<b>DOCKETED</b>	
<b>Docket Number:</b>	11-AFC-04
<b>Project Title:</b>	Rio Mesa Solar Electric
<b>TN #:</b>	233556
<b>Document Title:</b>	Applicant's Supplemental Response to Data Request 16 and 26 Additional Information Regarding Water Resources
<b>Description:</b>	N/A
<b>Filer:</b>	Marichka Haws
<b>Organization:</b>	California Energy Commission
<b>Submitter Role:</b>	Commission Staff
<b>Submission Date:</b>	6/19/2020 3:14:21 PM
<b>Docketed Date:</b>	6/19/2020

## **APPLICANT’S SUPPLEMENTAL RESPONSE TO DATA REQUEST 16 AND 26: ADDITIONAL INFORMATION REGARDING WATER RESOURCES**

In this section of Applicant’s Supplemental Response to CEC Staff Data Requests 16 and 26, Applicant describes the changes to the Water Resources section that will result from the changes to the Project Description per the removal of RMS 3. Per staff’s request, Applicant uses a strike-out/underline format to identify changes to the Water Resources section of the Application for Certification that will result from the changes to the Project Description.

Path: G:\gs\projects\157\2765\1002\map\_docs\mxd\Supplemental\WaterRes\HEC\_RAS\_100yr.mxd, diana\_smith, 6/29/2012, 1:41:05 PM

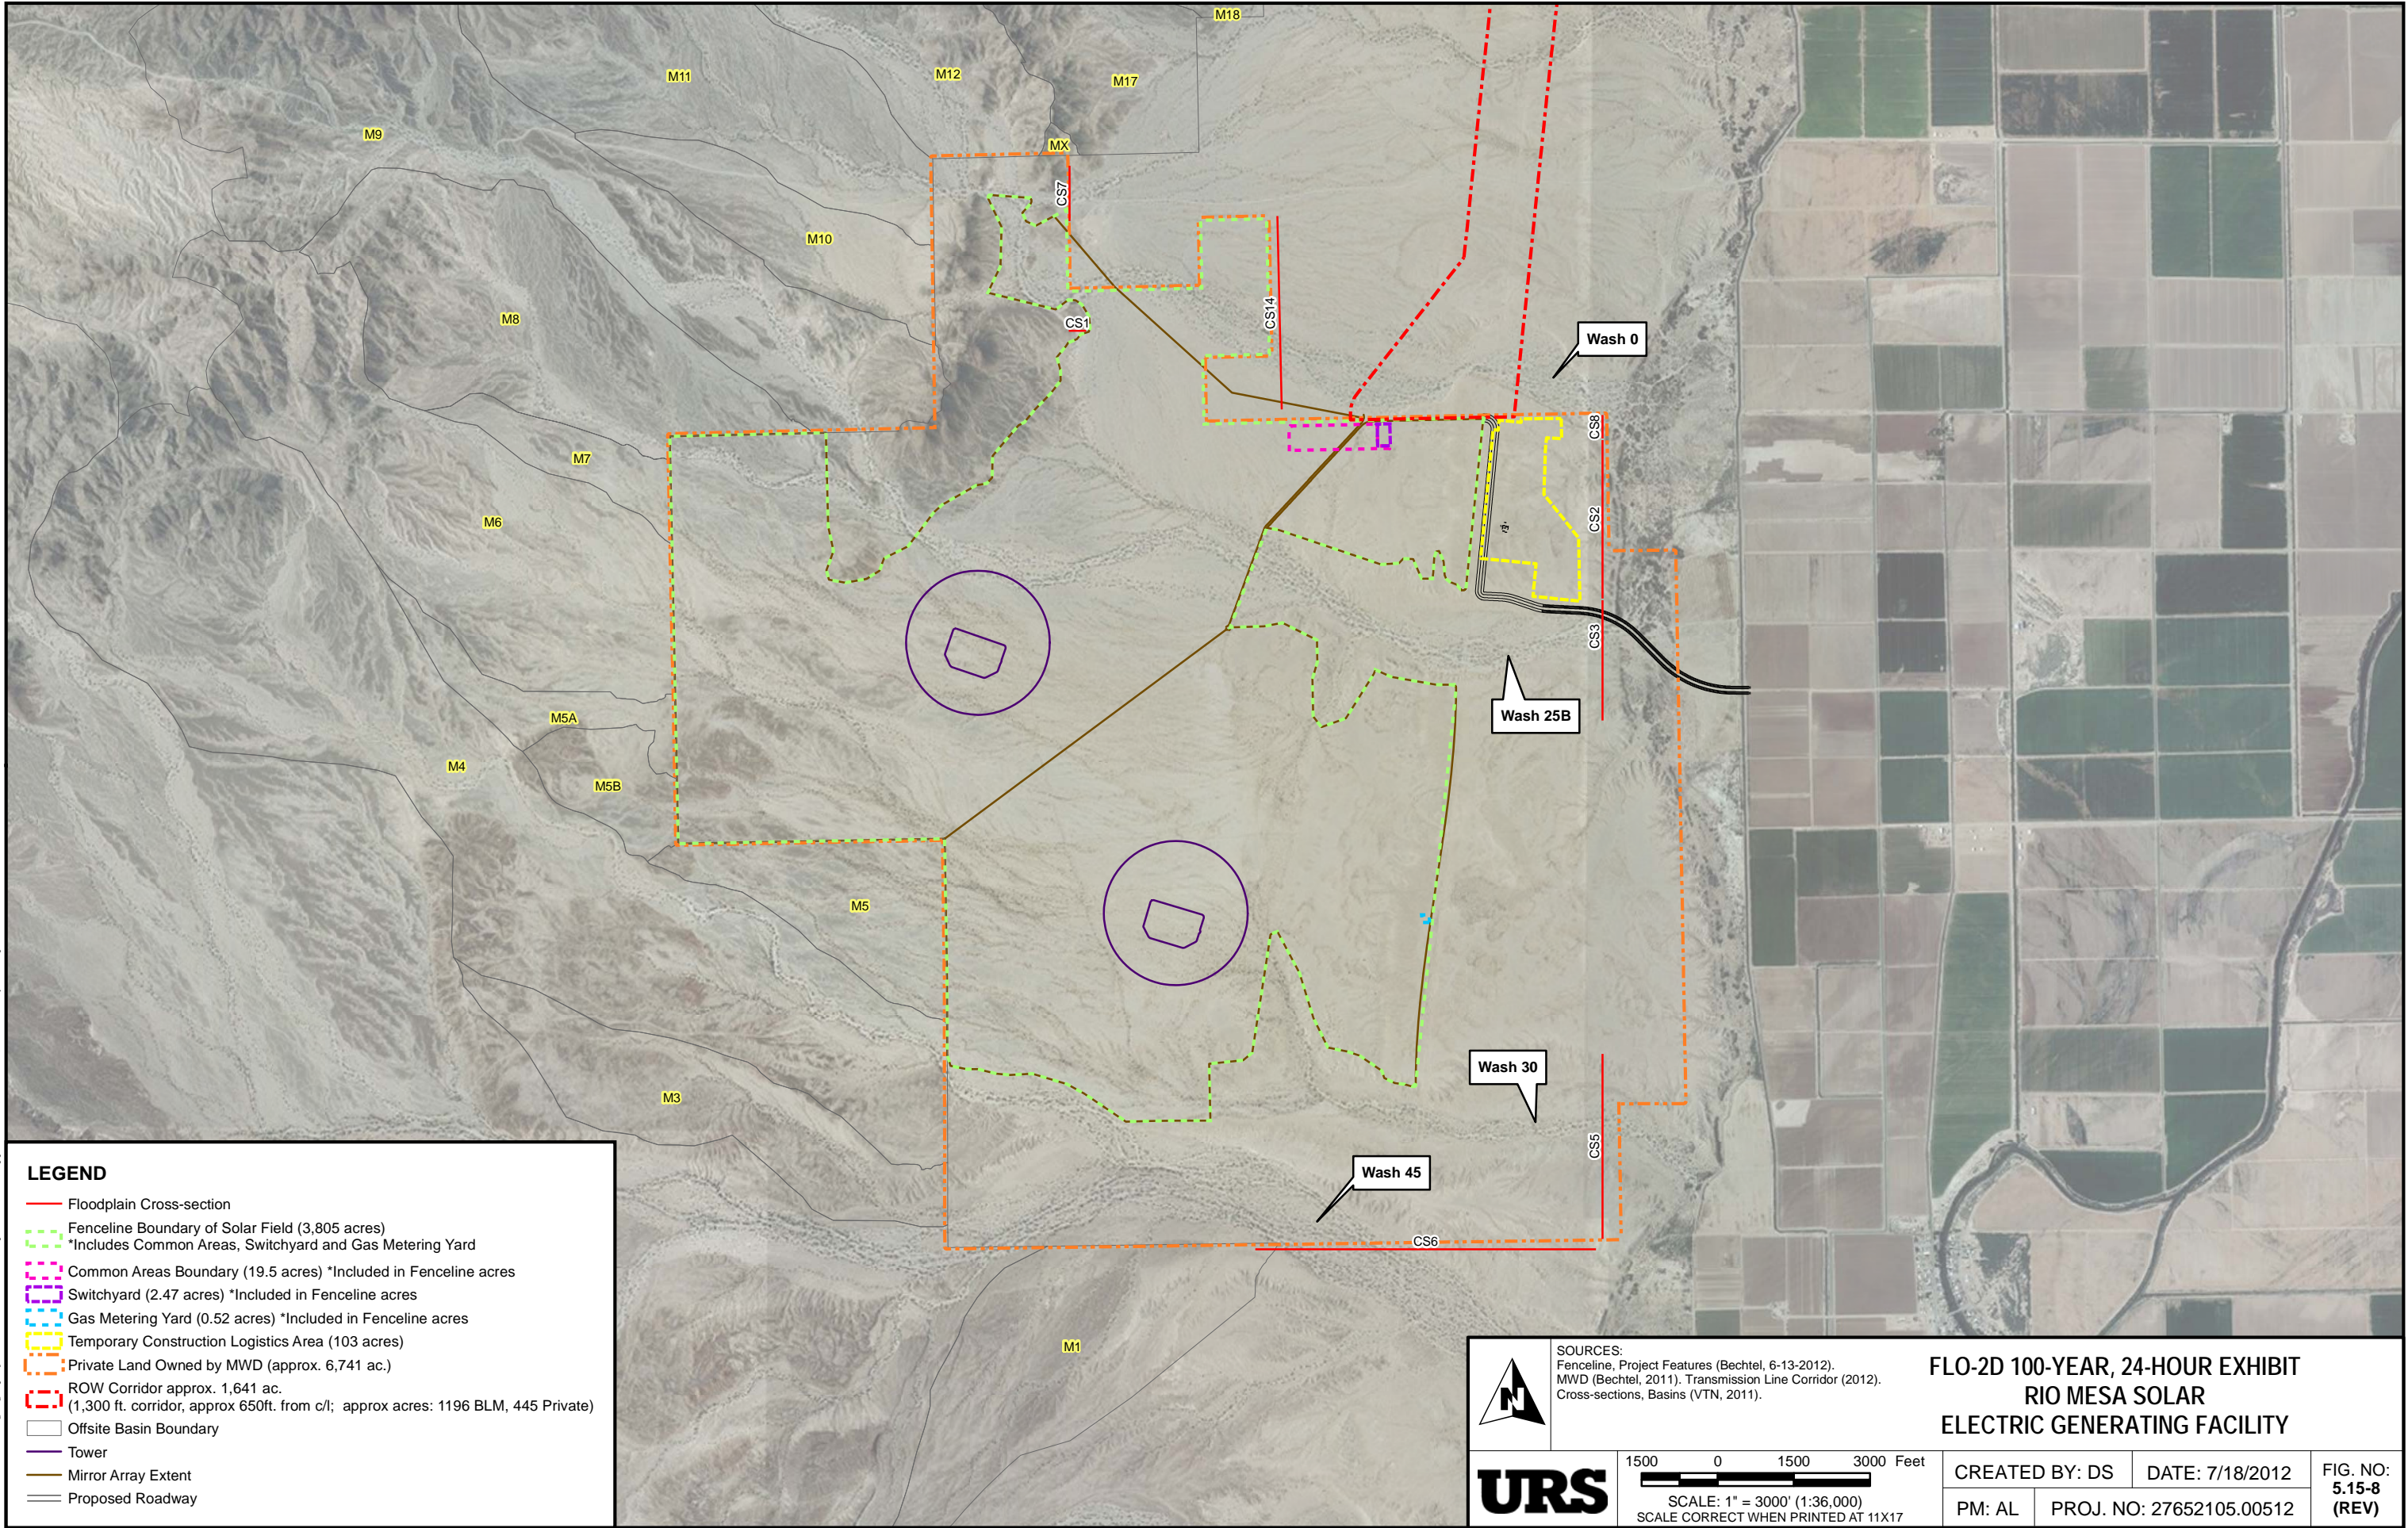
A summary of the 100-year, 24-hour existing conditions hydraulic analysis results from the VTN study are provided in Table 5.15-5 below. This table provides the maximum depth and velocity within a particular on-site wash. Generally, the discharges range from ~~64~~105 to 6,154 cubic feet per second (cfs), the maximum flow depths range from approximately ~~1.2~~1.7 to 4.5 feet, and maximum velocities range from ~~2.9~~3.6 to 6.1 feet per second (fps). The flow rates, depths, and velocities associated with the 100-year storm indicate the potential for minor to moderate scour, erosion, and sedimentation within the washes during extreme flood events. Additional return frequency results (2-, 5-, 10-, and 25-year) are provided in the VTN report in Appendix 5.15A. The wash locations are shown on Figure 5.15-7 (rev).

Path: \\S082-GIS-01\gis\projects\1577-27651002\map\_docs\mxd\Supplemental\WaterRes\Flo2D\_100yr.mxd, paul\_moreno, 7/18/2012, 8:37:28 AM

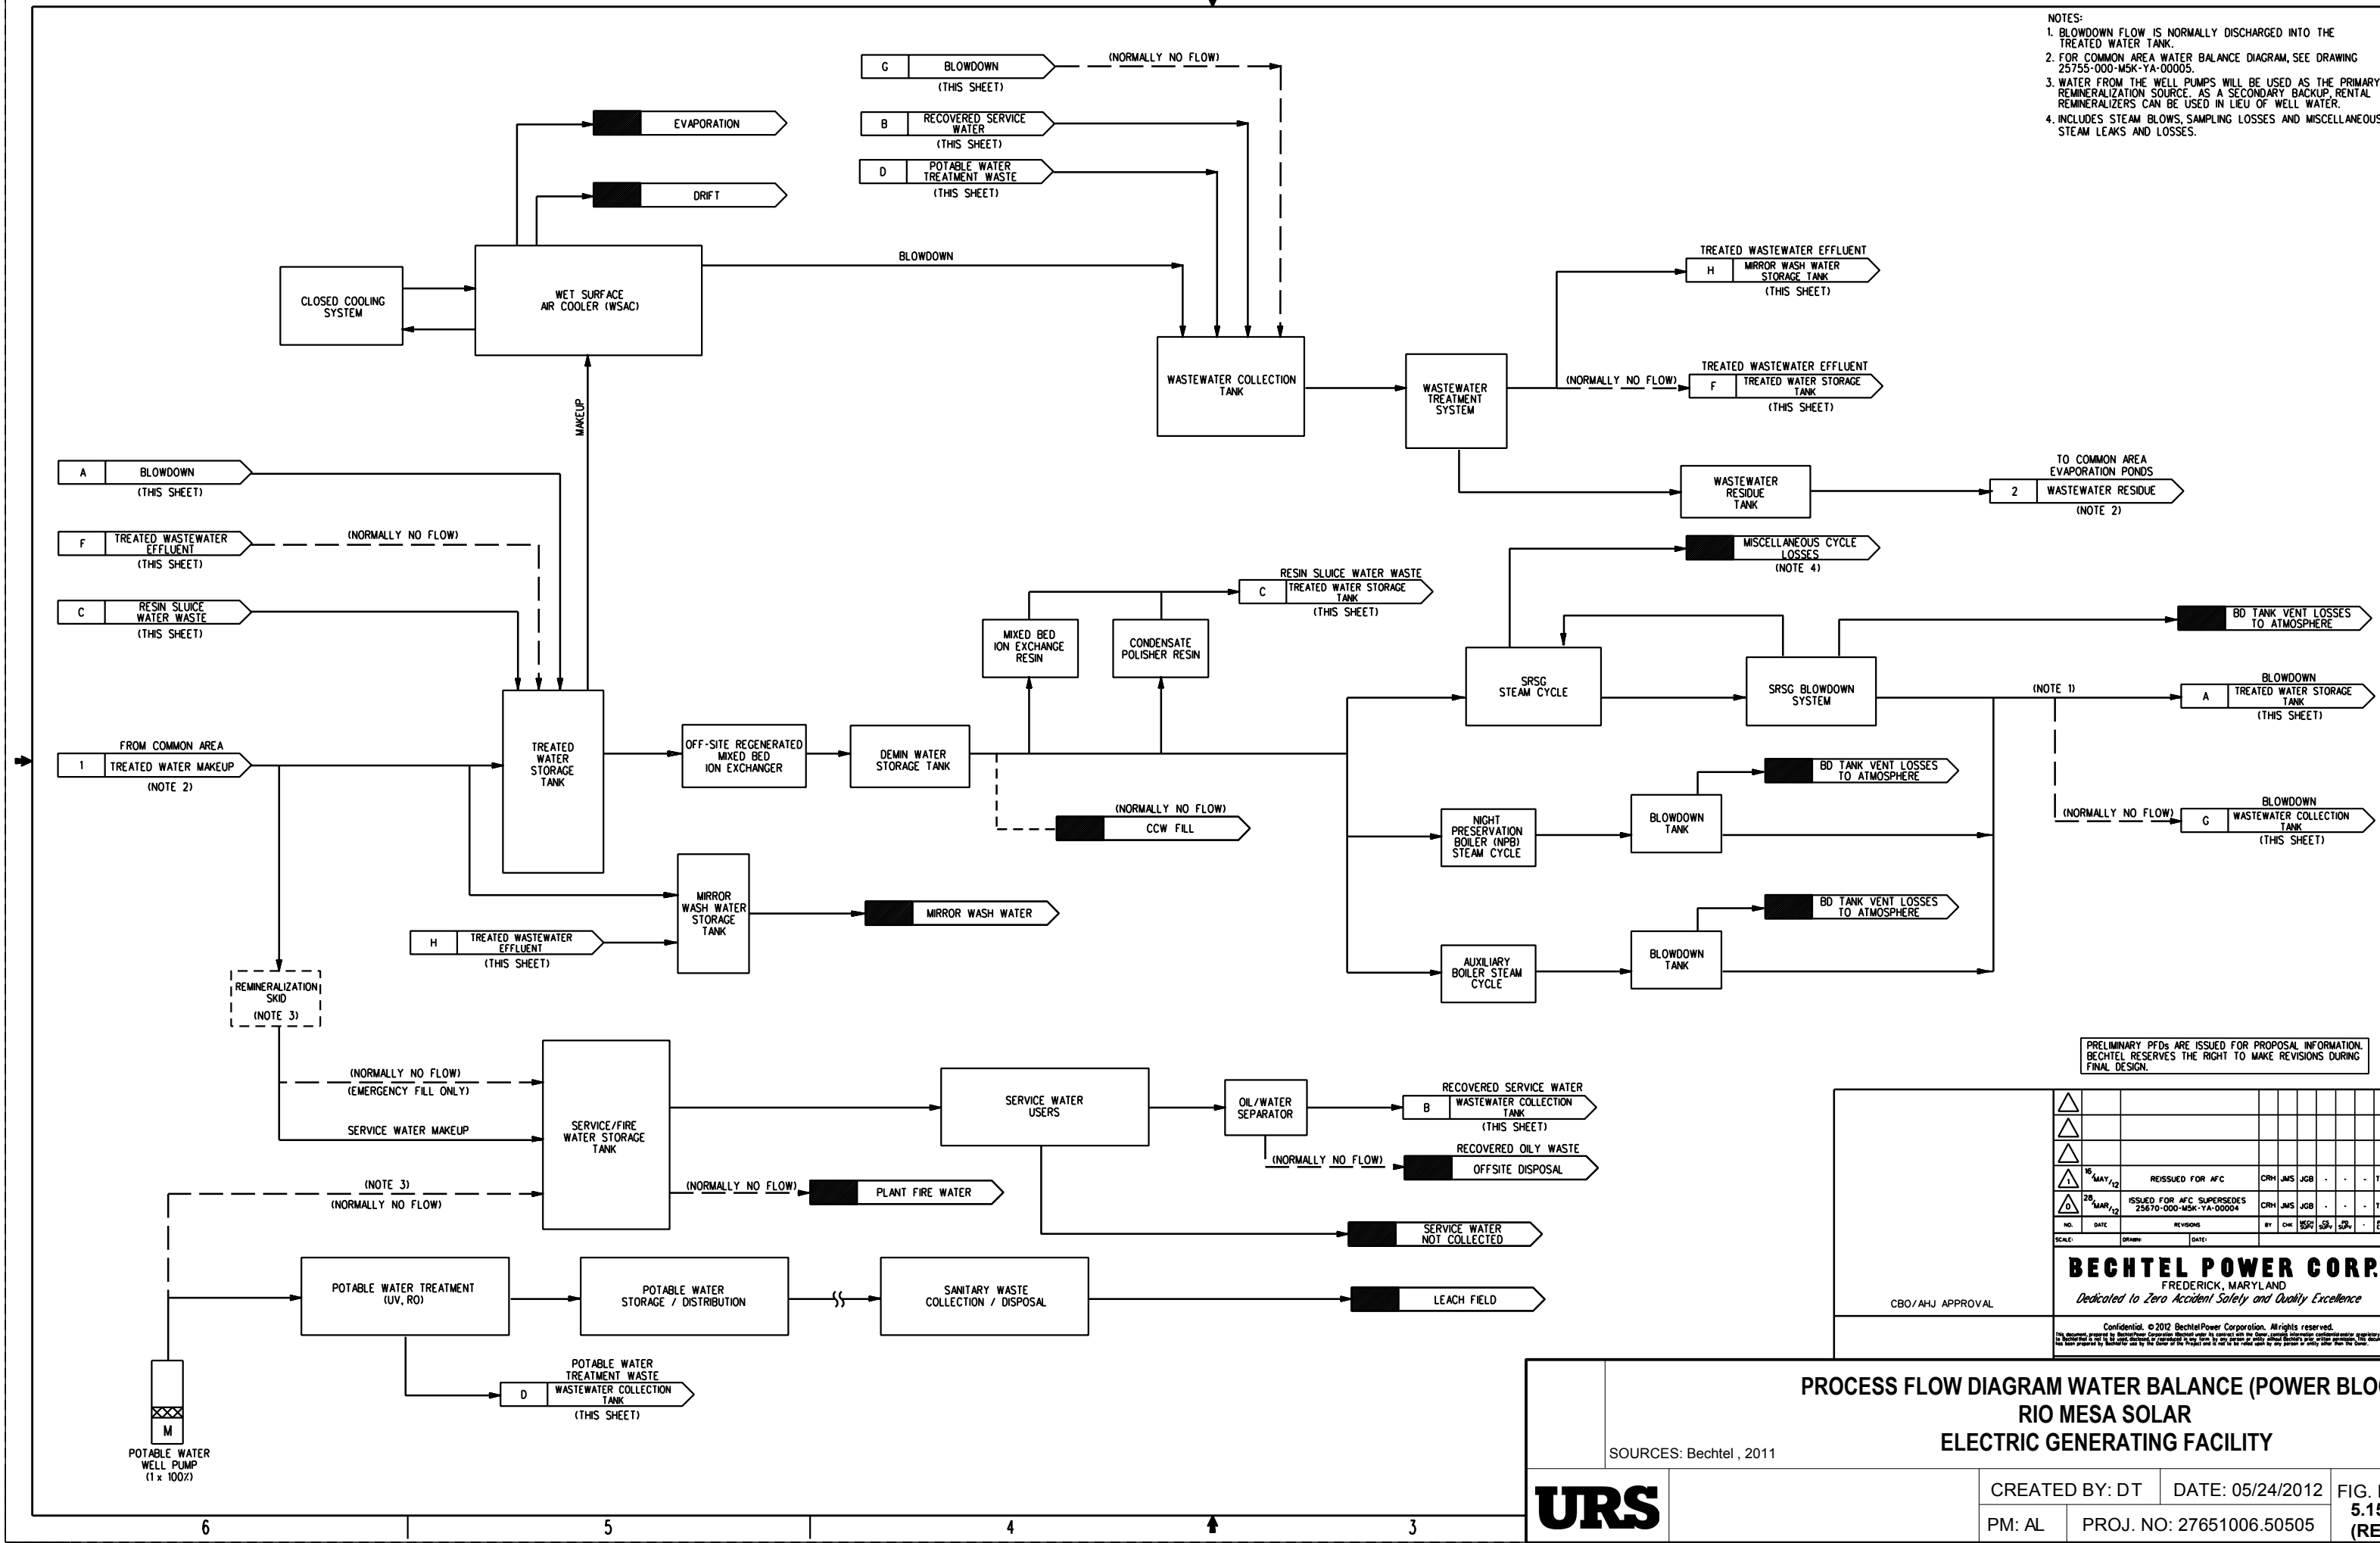
The results indicate that there is a slight increase in the volume of runoff leaving the project area. This is expected due to the increased impervious area caused by the Project's development. The flow rates generally experienced slight increases due to the added impervious area and new drainage channels. The flow results at cross sections located at the downstream end of the proposed project area are shown in Table 5.15-8 below. The corresponding cross section locations used in the FLO-2D analysis are shown on Figure 5.15-8 (rev).

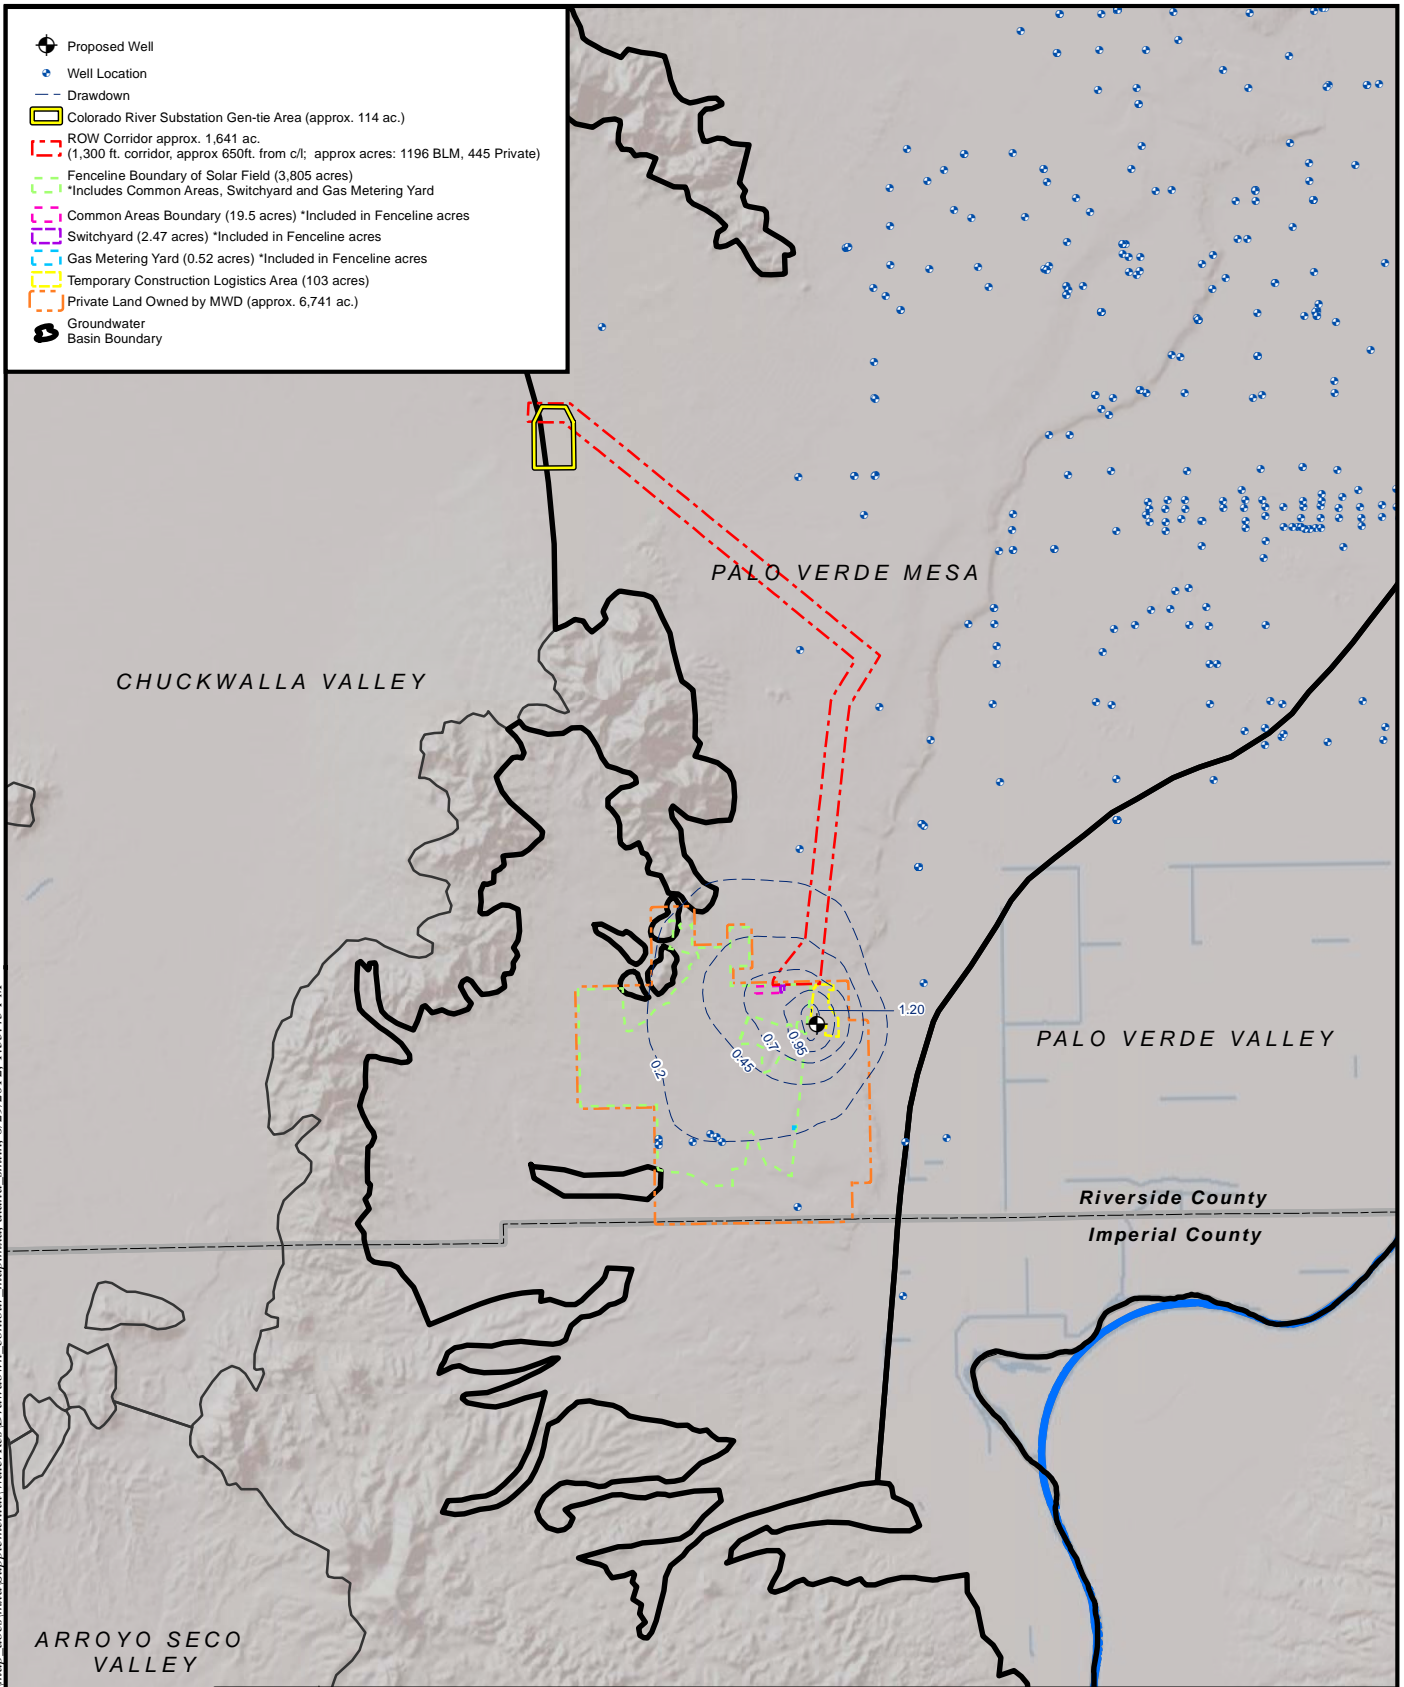
Figure 5.15-11 (rev) shows that drawdown from Project pumping will be limited to the PVMGB to areas very close to the project site. Contoured drawdown extends into the PVVGB approximately 0.5 mile<sup>1</sup>; however, drawdown greater than 0.5 feet<sup>1</sup> is limited to the PVMGB. Maximum drawdown near the Project pumping wells is expected to be approximately 1.3 feet<sup>1</sup> or less at the end of pumping. The maximum observed drawdown will occur during construction pumping and is predicted to be less than approximately 3 feet<sup>1</sup> near the pumping wells.
